**SUBDIVISION,
PLANNED UNIT DEVELOPMENT &
PLANNING APPROVAL
STAFF REPORT****Date: December 3, 2020****APPLICANT NAME**

St. Mary Catholic School Subdivision

LOCATION107 North Lafayette Street
(North side of Old Shell Road, extending to the East side of
Providence Street and the West side of North Lafayette
Street).**CITY COUNCIL
DISTRICT**

CONTEMPLATED USESubdivision Approval to create one legal lot of record from
two existing legal lots of record and one existing metes-
and-bounds parcel; Planned Unit Development Approval
to amend a previously approved Planned Unit Development
to expand the site boundary and construct a covered, open-
air multi-use facility, including volleyball and basketball
courts, on the existing playground; and Planning Approval
to amend a previously Planning Approval to expand the site
boundary and construct a covered, open-air multi-use
facility, including volleyball and basketball courts, on the
existing playground.**TIME SCHEDULE
FOR DEVELOPMENT**

SITE PLAN

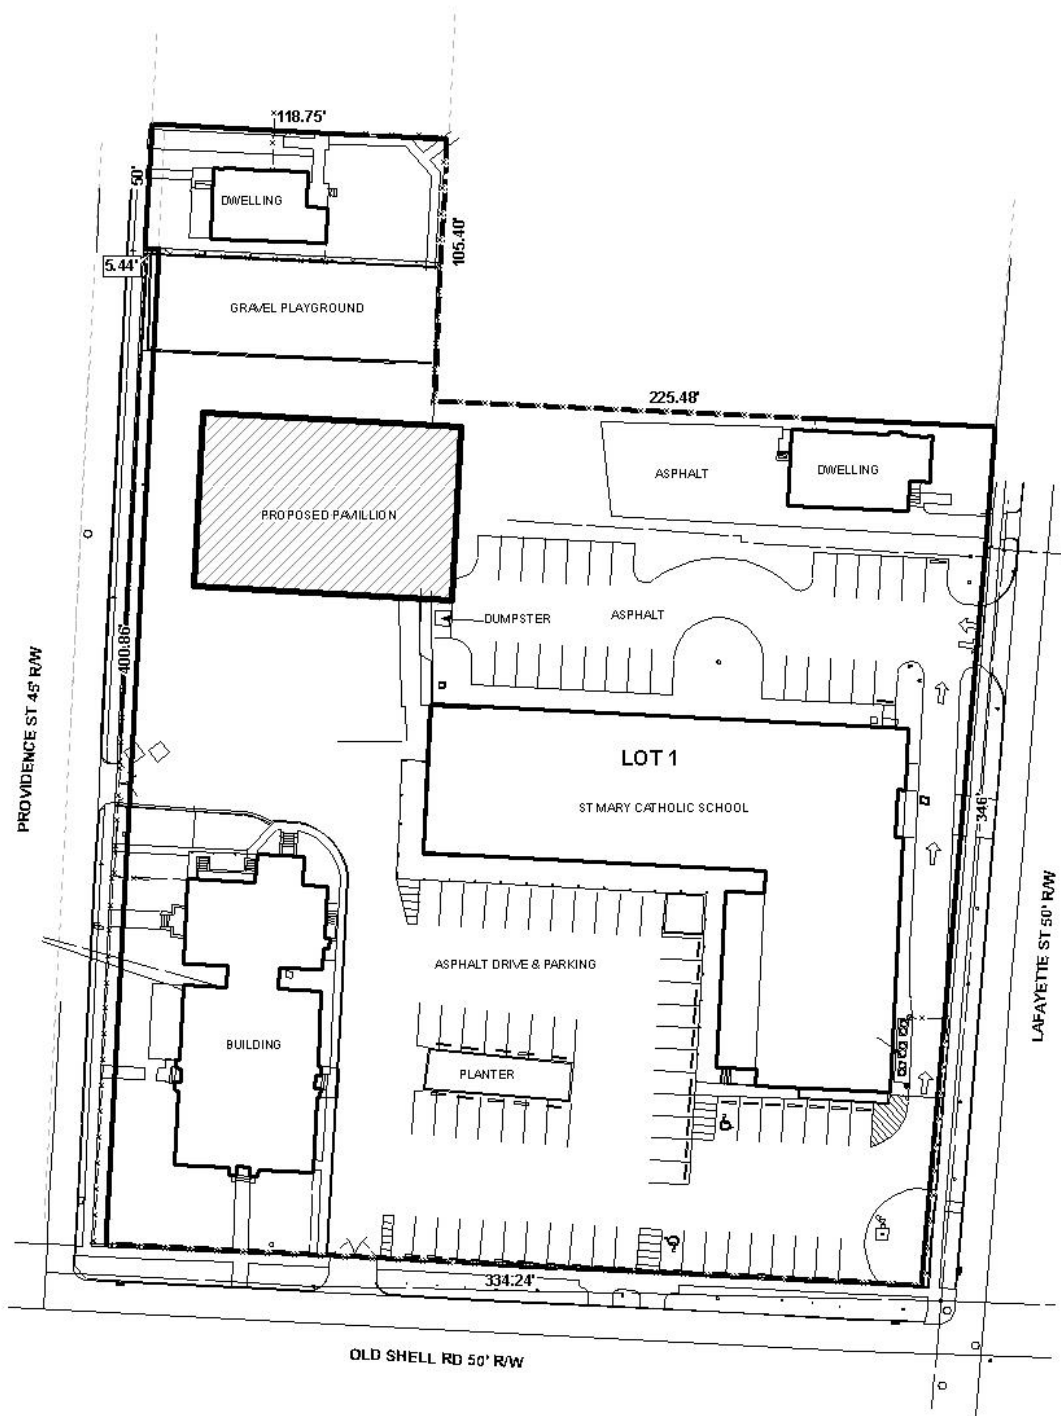
The PUD addresses the multiple structures on the proposed single lot. The site plan indicates the existing school buildings, two existing dwelling buildings and the proposed pavilion building. Calculations on the site plan indicate compliance with the landscaping requirements of the Zoning Ordinance, and a note states that compliance with both the landscaping and tree planting requirements will be indicated on the site plan submitted for project construction. The site plan indicates that 87 parking spaces are provided on site, but does not provide the calculations for such, nor does it provide any information on the proposed use of the two dwellings being added

to the site or the parking required for their use. Therefore, the site plan should be revised to provide parking calculations for all buildings and proposed uses on the over-all site.

Pertaining to the proposed pavilion, the indicated setback off the Providence Street right-of-way is 21', which would not meet the normal minimum 25' building setback. As previously stated, since the site is within a historic district, setbacks would be governed by Section 64-3.G. Historic District Overlay requirements of the Zoning Ordinance. Therefore, the proposed setback off Providence Street appears to be in order. However, the distance from the Northeast corner of the pavilion to the adjacent R-1 property to the North is not provided and should be at least ten feet. Therefore, the site plan should be revised to indicate the pavilion would meet the ten-foot setback requirement off the R-1 property to the North.

The site abuts R-1 properties to the North. As no residential buffer is indicated on the site plan, it should be revised to provide a residential buffer, in compliance with Section 64-4.D.1. of the Zoning Ordinance. The site plan indicates a dumpster is to be provided, and public sidewalks currently exist along all street frontages. The site plan indicates gates at the Old Shell Road and Providence Street entrances to the site. Therefore, a note should be required on the site plan stating that those gates are to remain open during the hours of operation of all school-related activities.

The narrative furnished by the applicant addresses the proposed use of the pavilion, but not those of the two dwellings. Therefore, the applicant should provide a revised narrative addressing the proposed uses of those two buildings. The Planning Approval site plan should also be revised as per required revisions of the PUD site plan.

- 1) revision of the site plan to provide parking calculations for all buildings and proposed uses on the over-all site;
- 2) revision of the site plan to indicate the site configuration after all dedications required by the Subdivision;

- 3) revision of the lot size label to reflect any required dedications, or the furnishing of a table on the site plan providing the same information;
- 4) placement of a note on the site plan stating that all setbacks shall be determined by Section 64-3.G. Historic District Overlay requirements of the Zoning Ordinance;

- 5) revision of the site plan to indicate the pavilion would meet the ten-foot setback requirement off the R-1 property to the North;
- 6) revision of the site plan to provide a residential buffer, in compliance with Section 64-4.D.1. of the Zoning Ordinance, where the site abuts residential properties;

- 7) placement of a note on the site plan stating that the driveway gates along Old Shell Road and Providence Street are to remain open during the hours of operation of all school-related activities; and

- 1) submission of a revised narrative addressing the proposed uses of the two dwelling buildings;
- 2) revision of the site plan to provide parking calculations for all buildings and proposed uses on the over-all site;

- 3) revision of the site plan to indicate the site configuration after all dedications required by the Subdivision;
- 4) revision of the lot size label to reflect any required dedications, or the furnishing of a table on the site plan providing the same information;

- 5) placement of a note on the site plan stating that all setbacks shall be determined by Section 64-3.G. Historic District Overlay requirements of the Zoning Ordinance;

- 6) revision of the site plan to indicate the pavilion would meet the ten-foot setback requirement off the R-1 property to the North;
- 7) revision of the site plan to provide a residential buffer, in compliance with Section 64-4.D.1. of the Zoning Ordinance, where the site abuts residential properties;

- 8) placement of a note on the site plan stating that the driveway gates along Old Shell Road and Providence Street are to remain open during the hours of operation of all school-related activities; and
